SUBJECT: INTERFACING SYSTEM LOCA INSPECTION (50-382/90-200)

NRC Inspection Report: 50-382/90-200

Facility Name: Waterford 3

Figure 1. Waterford 3 High Pressure Safety Injection System Showing Component Locations

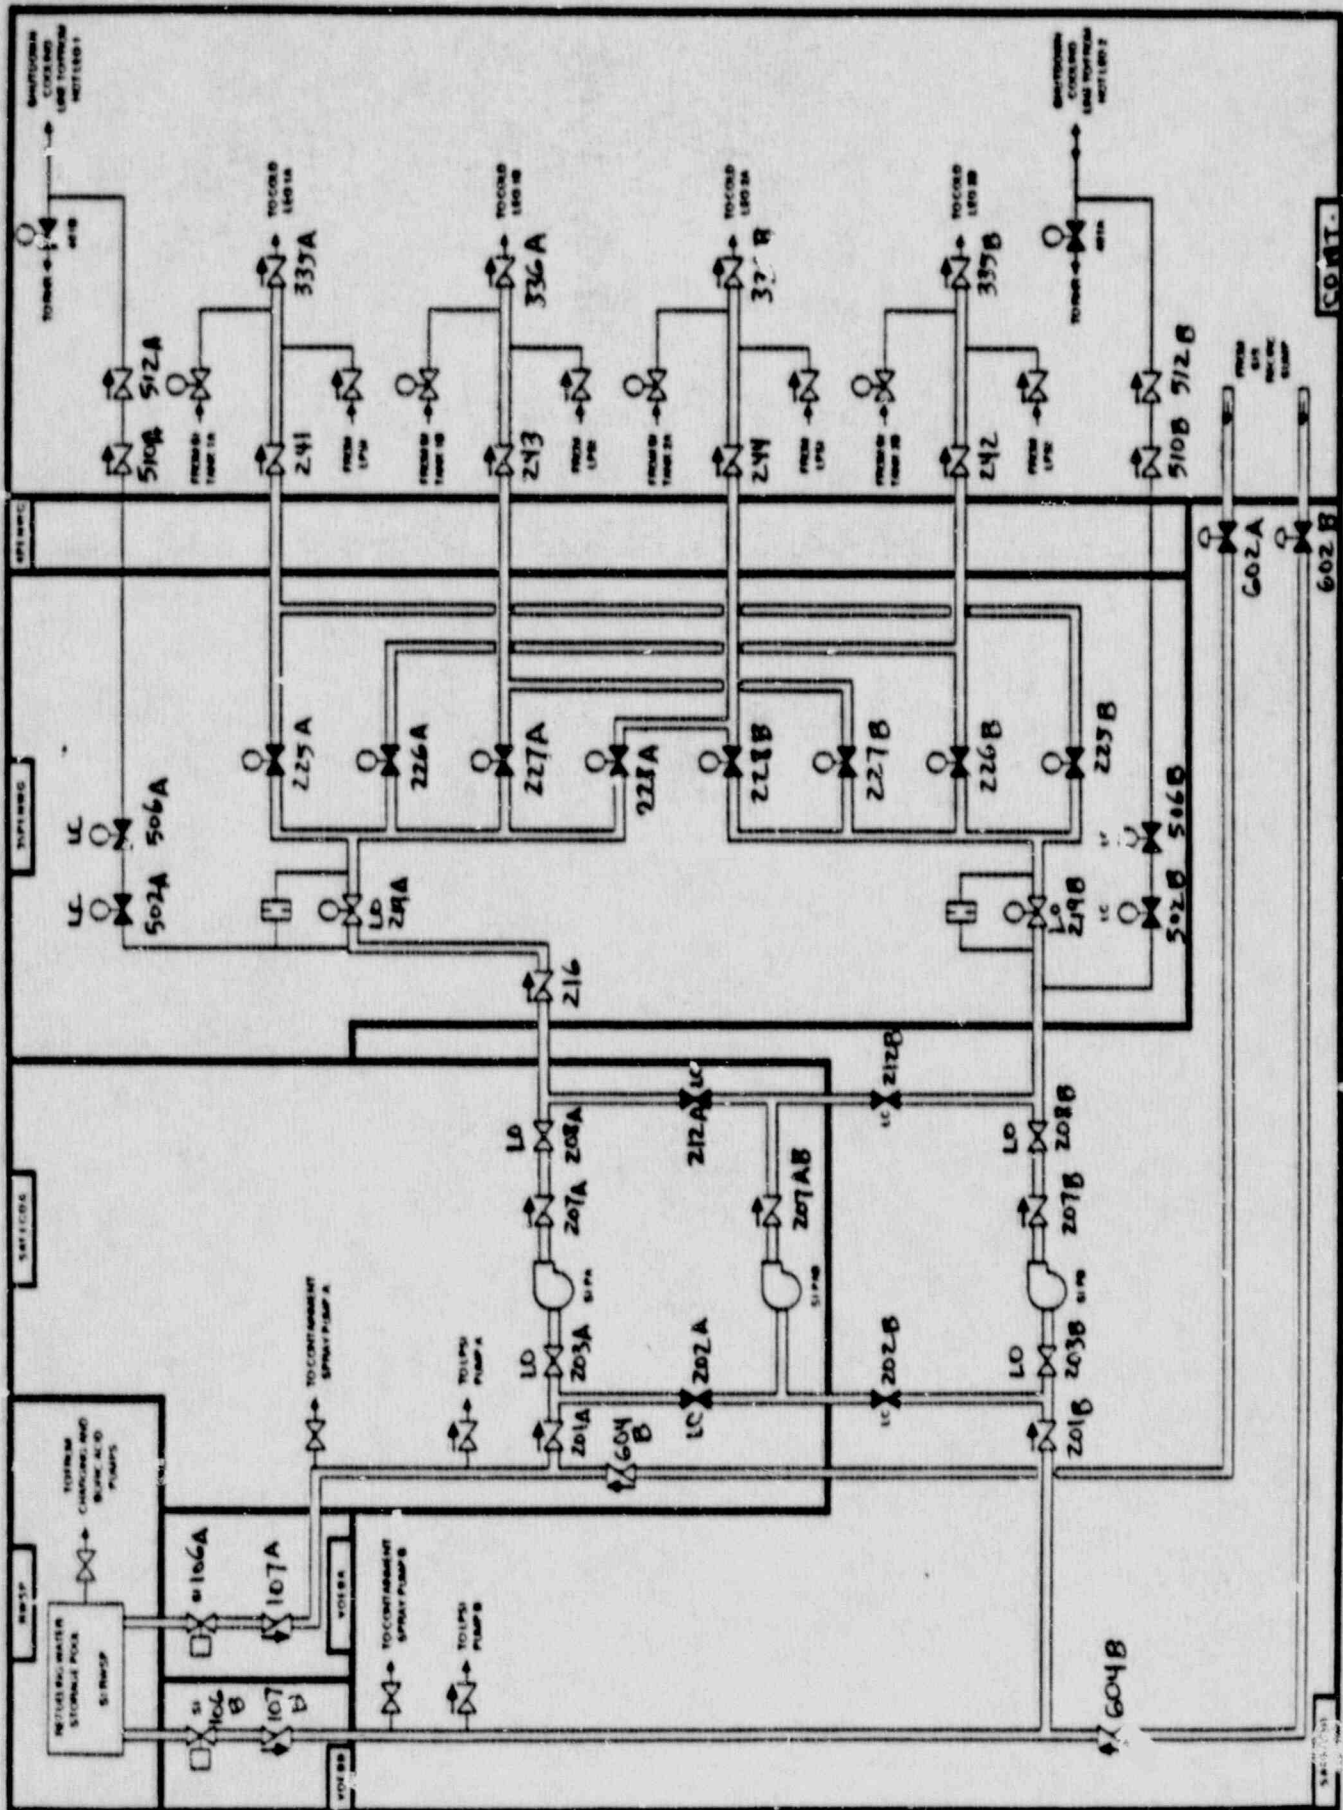
Two HPSI pumps, A and B, are aligned to inject water into the four cold-leg flow paths. An additional swing pump A/B can be manually aligned to provide for injection. In each of the HPSI flow paths, there were two check valves inside the containment and a normally closed motor-operated valve (MOV) in the reactor auxiliary building (RAB). Injection into the hot-leg flow paths can be aligned manually through two injection lines. Each of the injection lines had two check valves inside the containment and two closed MOVs in the RAB. The MOVs in the hot-leg injection flow path were procedurally controlled and locked closed with key-operated control switches in the control room. Appendix B, Figure 1, shows a diagram of the HPSI system and the relative location of the HPSI components within the RAB and the containment building.

The closed MOVs were the high-to-low pressure interfaces. The containment penetration piping downstream from the closed MOVs, including the two check valves, had a design pressure of 2485 psig. The piping in the RAB upstream of

the MOVs up to the pump discharge had a design pressure of 1950 psig. All the normally closed MOVs on the HPSI injection lines that were in the RAB were easily accessible for local operation. However, operation of these valves could be restricted by a break or by the inability of the valve to close against high flows or pressure differentials if they had been opened.

If an ISLOCA break occurred at the suction portion of an HPSI pump and the refueling water storage pool (RWSP) outlet isolation valves (SI-106 A or B) could not be closed, the RWSP water would be lost. This would affect long-term recovery and core cooling, and valves SI-106 A and B were not readily accessible for local operation.
